Special Use Permit #2024-00041
404-A East Alexandria Avenue

Application	General Data	
Public Hearing and consideration of requests for Special Use Permits to construct a single-unit dwelling on a vacant substandard lot and for a lot without frontage on a public street	Planning Commission Hearing:	November 7, 2024
	City Council Hearing:	November 16, 2024
Address: 404-A East Alexandria Avenue	Zone:	R-2-5/ Residential
Applicant: Eric Teran and Daniela Gross	Small Area Plan:	Potomac West

Staff Recommendation: APPROVAL subject to compliance with all applicable codes, ordinances, and the recommended permit conditions found in Section III of this report.

Figure 3 - North Elevation (Front)

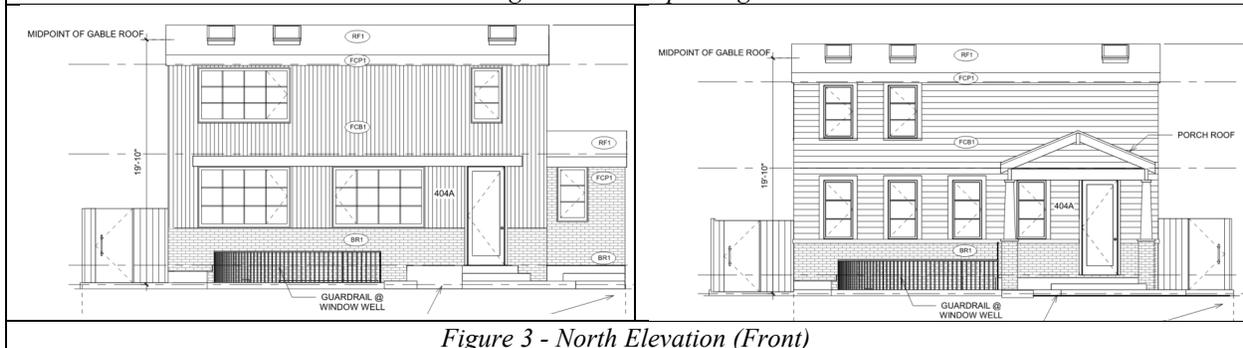
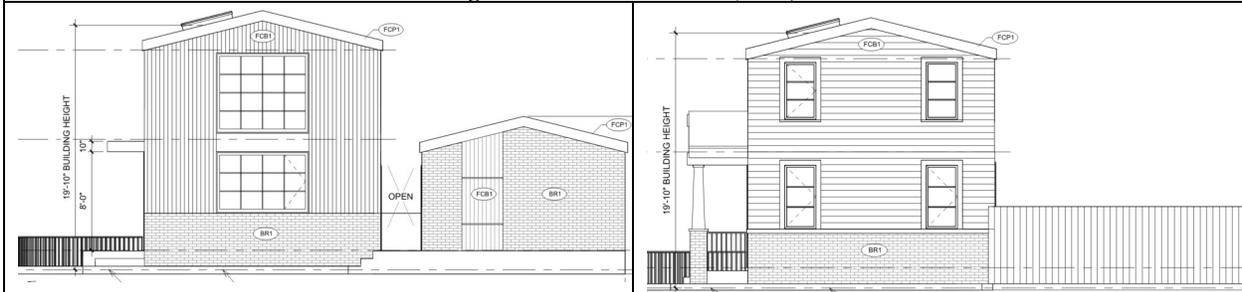
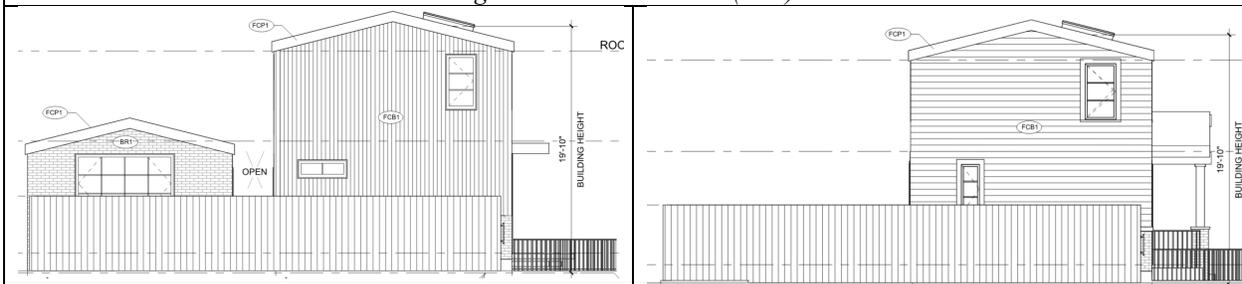
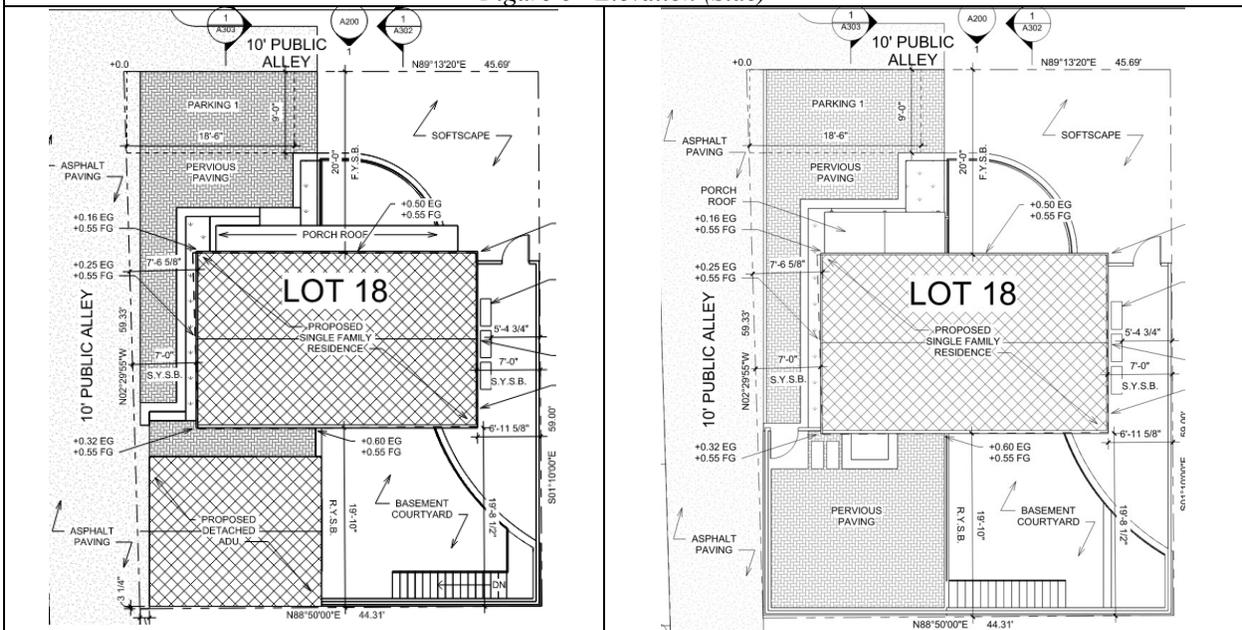
- c. **MARGINAL DIFFERENCE: With the exception of the changes in the size of windows in figure 4 of the staff report, there is NO CHANGE in symmetry of the window positioning.** Furthermore, it is confusing as to why staff chose to highlight symmetry as the defining “change” when the applicants simply described their adjustment as “windows resized” with no mention of consideration of symmetry of window placement (pg. 50-51 of new applicant materials, also labeled as pg. 87-88 of the current staff report).

- The 4-quadrant elevations referenced (figures 3-6, incorrectly referenced in the writeup above as figures 2-5) show drawings comparing the previous vs. new application designs; **all have the same dimensions for the proposed dwelling - THERE IS NO DIFFERENCE.**

The applicants’ have changed the previous contemporary architectural style. The new design would have a predominately Colonial Revival style with a small front porch, a low-pitched side facing gable, symmetrical window placement, and rectangular massing. The front porch would also incorporate Craftsman style tapered porch columns. The windows would have a contemporary feel with three divided lites. Figures two through five, below, show the proposed elevations as they compare to the previous application. The applicant has removed the accessory dwelling unit from their proposal.
